REQUESTOR NAME: **Clean Energy Association of B.C. (CEBC)**

TO: **BRITISH COLUMBIA HYDRO & POWER AUTHORITY**

PROJECT NO: 1598933

APPLICATION NAME: **Waneta 2017 Transaction Application (“Waneta 2017” or “Application”)**

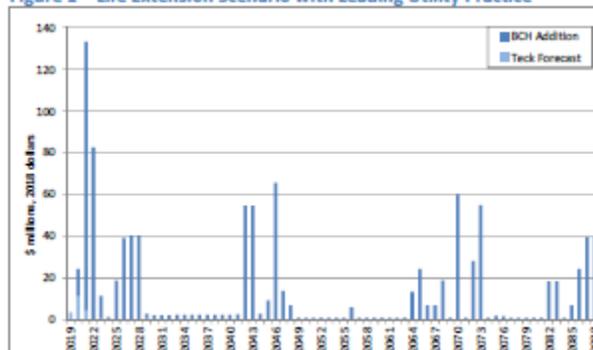
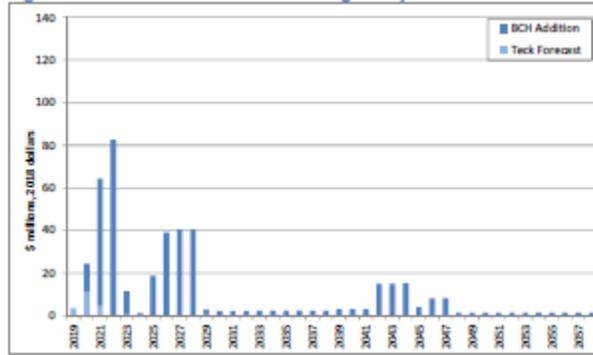
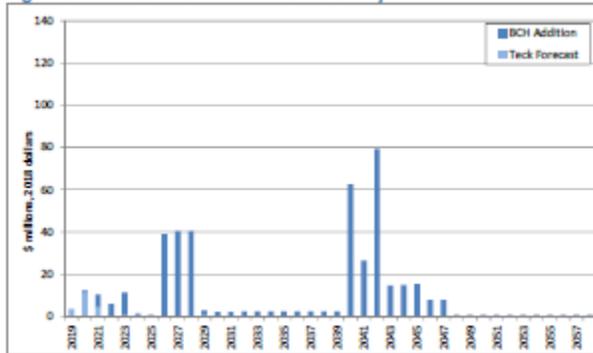
- 8.1 Why is it deemed necessary to have such an incredible amount of redaction? Since all the terms of this deal have already been worked out, and these are only forecasts of possible future needs, what sensitive negotiations would be compromised by revealing these forecasts? Can BC Hydro please be less sweeping and more discriminatory in its use of redaction, confining it to only those specific items that could be commercially sensitive?

- 8.2 The charts reveal the total estimates and the differences between BC Hydro and the Seller, but it is extremely difficult, and potentially inaccurate to try to estimate the numbers from the charts. What is the total amount of the difference in each scenario: a) over the first 20 years; b) over the first 40 years; and c) over 70 years, in the case of the Live Extend scenario?

- 8.3 Please provide a working Excel model that contains the numbers that produced these charts.
- 8.4 Why is there such an enormous difference between Teck’s estimates and BC Hydro’s estimates? In view of the fact that Teck will have a 2/3 majority of the votes on the Operating Committee, will BC Hydro likely have to bear this difference in cost on its own account? How much of these differences does BC Hydro expect to be responsible for?

- 8.5 What amounts has BC Hydro included in its NPV analyses for these future capital expenditures?
- 8.6 Presumably in each Harvesting scenario, and even in the Extended Life scenario, there must be a decommissioning at the end of the asset life. What is BC Hydro’s estimate for the cost of this decommissioning? Are there different options for how the decommissioning would be performed? Please provide some degree of detail in these estimates.

The chart on page 15 of 90 shows the components of the Cost of Service for the 40 year period:

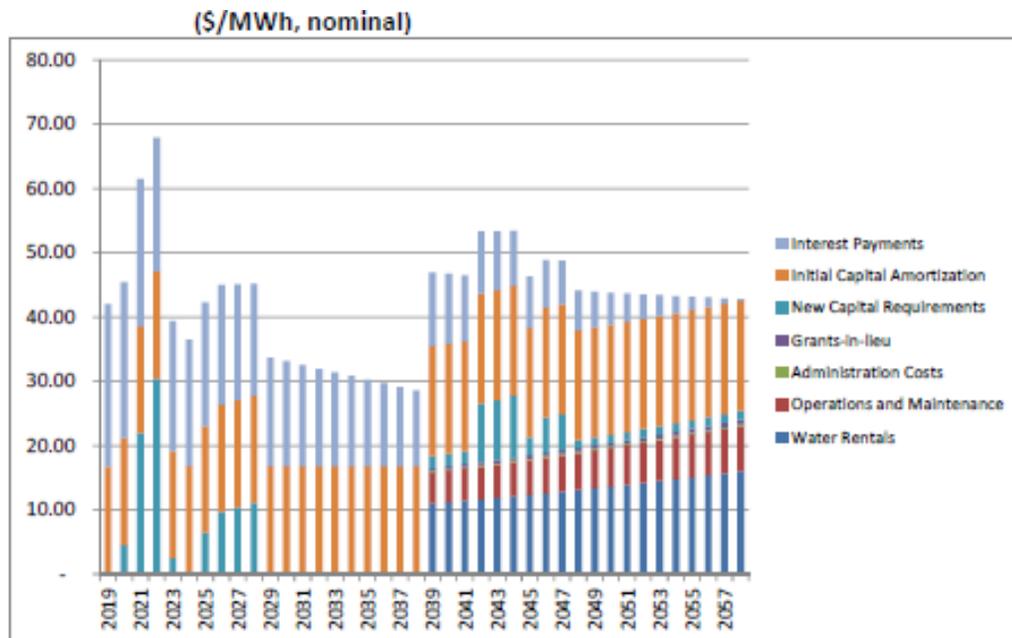
- 10.1 Please provide a working Excel model that produces this chart.
- 10.2 What is the assumed interest rate being used for the calculation of the interest payments?
- 10.3 If BC Hydro calculates its Weighted Average Cost of Capital (WACC) at 6%, then why is that WACC not being used for this interest calculation? Is BC Hydro assuming the purchase price will be 100% financed by debt, even though it has a target debt to equity ratio of 60/40?

**Figure 3 from Waneta 2017 Business Case:
Capacity-Adjusted Energy Price Forecast Comparison**

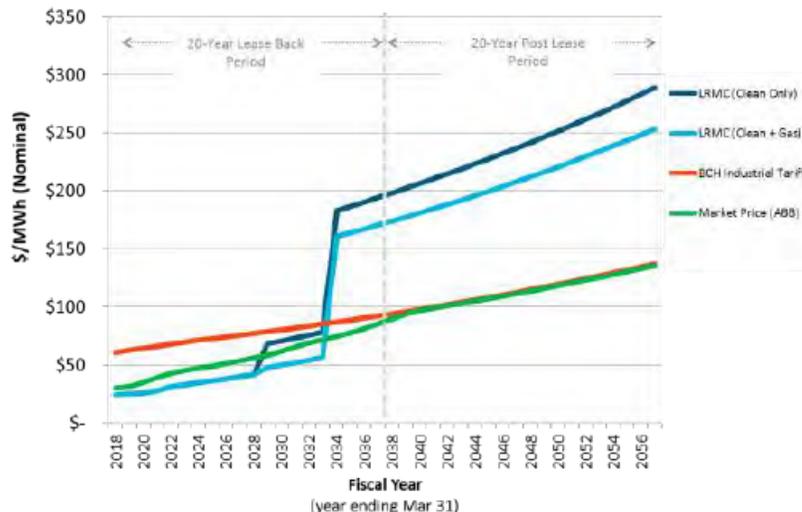
Figure 3 is intended to show the Capacity-Adjusted Energy Price Forecast Comparison, but it is entirely redacted. The same chart appears in Appendix N-1, with only the “Extrapolated” Market Price redacted.

- 12.1 Why is any redaction deemed necessary and, in particular, why is the “Extrapolated” Market Price considered such a sensitive forecast that it needs to be redacted? What sensitive negotiations could possibly be compromised by revealing this forecast?
- 12.2 Please provide a working Excel model that produces the chart in Figure 3, and also all of the other charts included in Appendix N-1 (i.e. Figures 3, 4, 5, 6, and 8), with the “Extrapolated” Market Price Curve included, if possible.
